Drawings

As instructed by the Examiner, Applicant has revised new Figure 6 to include the isolated-integrator band reject filter. Applicant has submitted herewith a proposed amended new Figure 6 to the Official Draftsperson. A marked up version of originally submitted new Figure 6 is attached. Applicant respectfully requests the Examiner's approval of amended new Figure 6.

VERSION WITH MARKINGS TO SHOW CHANGES MADE

FIG. 6

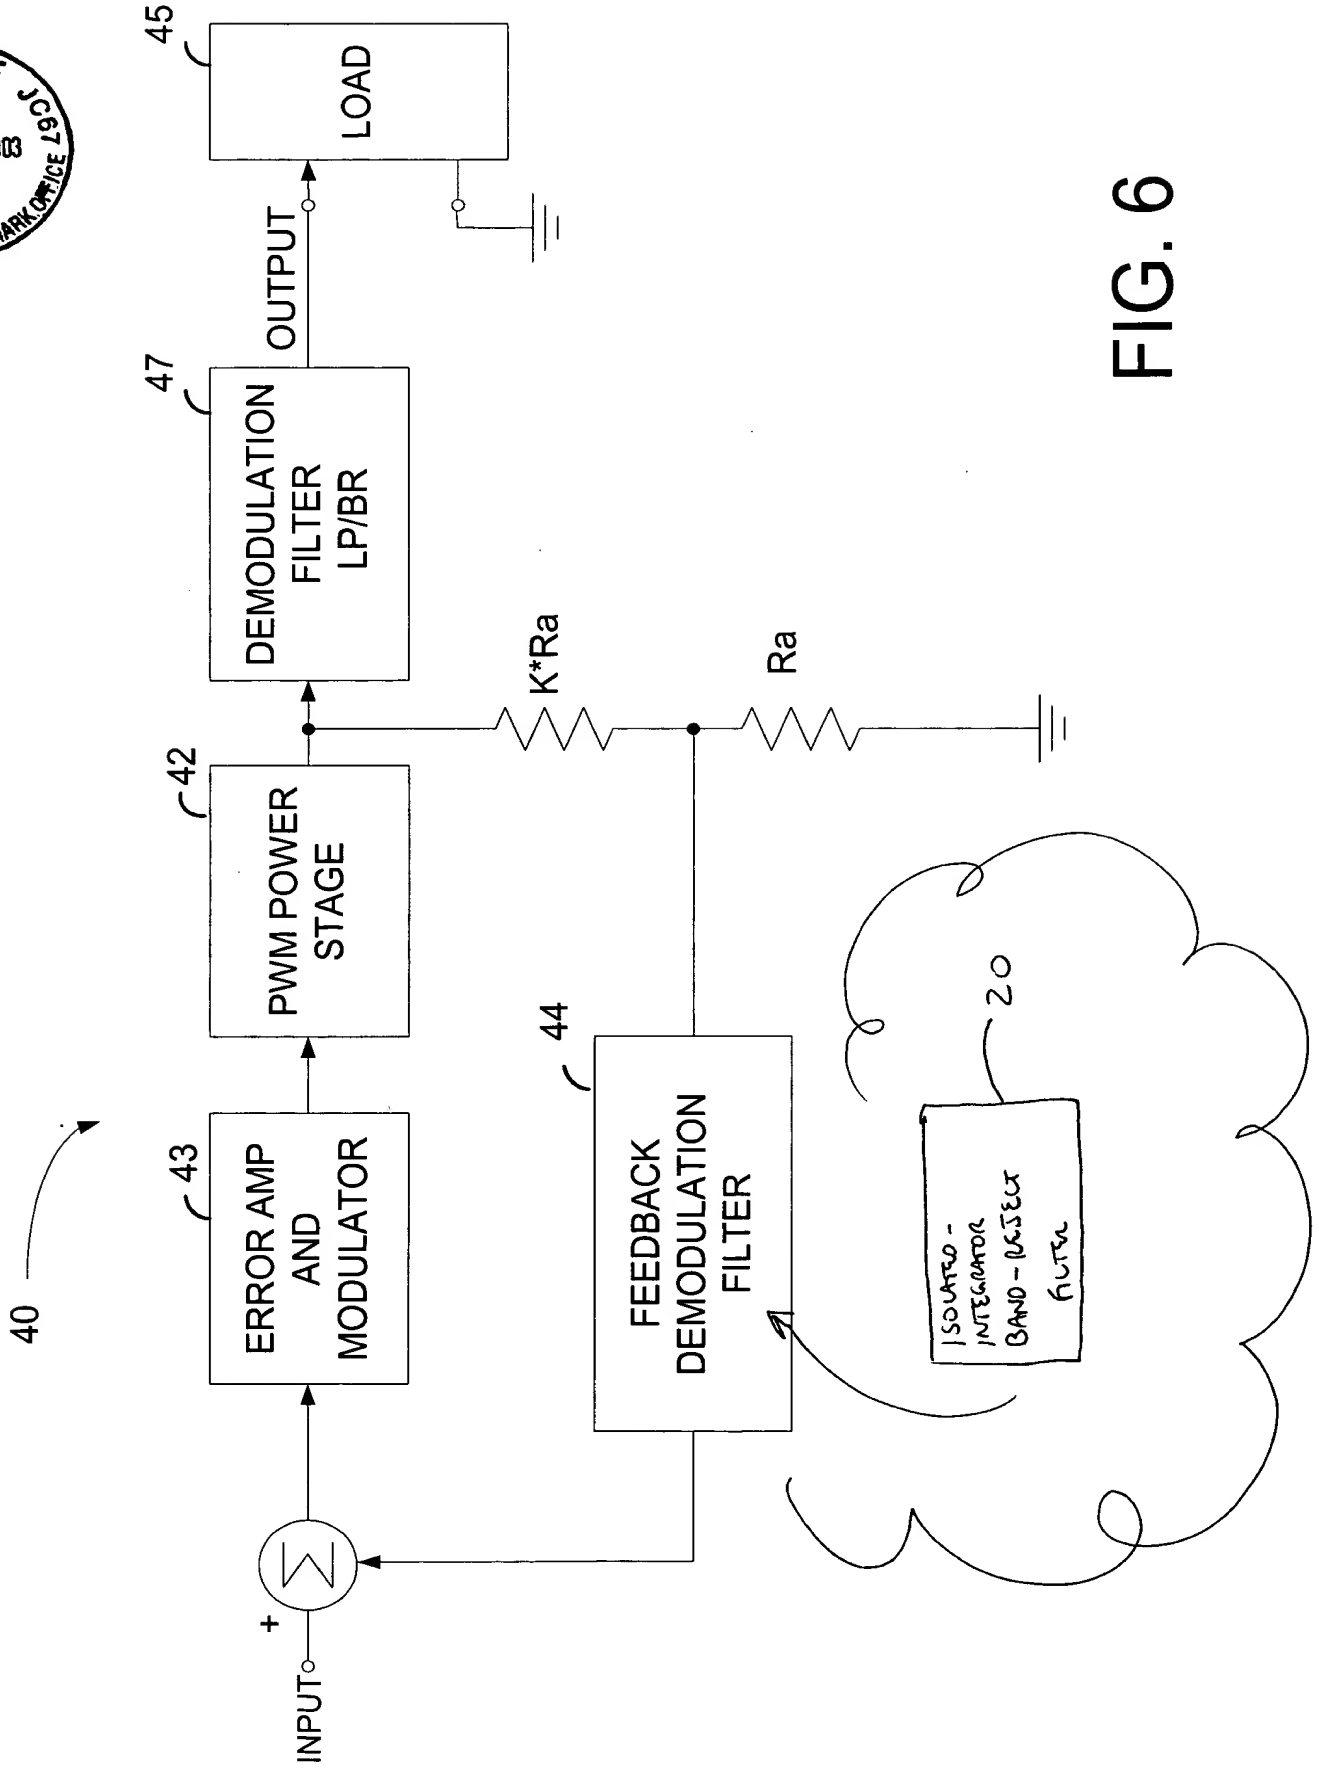
The Examiner has also indicated that "it is clear that new Fig. 6 does not include a feedback control loop additionally having an isolated integrator frequency-rejecting network as expressly disclosed on page 3." Applicant has submitted amended new Figure 6 to include the isolated-integrator band-reject filter as part of the feedback demodulation filter within the feedback control loop. As described in paragraph 46 of page 10 of the specification, "the feedback demodulation filter includes at least one isolated-integrator band-reject filter 20." Accordingly, the feedback control loop depicted in Figure 6 includes the feedback demodulation filter of which the isolated-integrator frequency rejecting network is a part.

The Examiner further contends that "ones skilled in the art would interpret the discussion from lines 9-11 [paragraph 11 of page 3] as reading only on the circuit shown in Fig. 5." The Examiner has also asserted that "the specification does not, in any way, enable one skilled in the art as to how to make any/or the invention of Fig. 6." Again Applicant respectfully disagrees and requests reconsideration.

One of ordinary skill in the art would regard the amended new Figure 6 simply as a visual form of that which is described by both paragraph 11 on page 3 and the new paragraph.

Clearly paragraph 11 of page 3 does not teach, suggest or disclose the filter 46 depicted in Figure 5. In addition, as previously discussed, Figure 6 is nothing more than an illustration of the elements discussed in paragraph 11 interconnected as described in paragraph 11. Further,
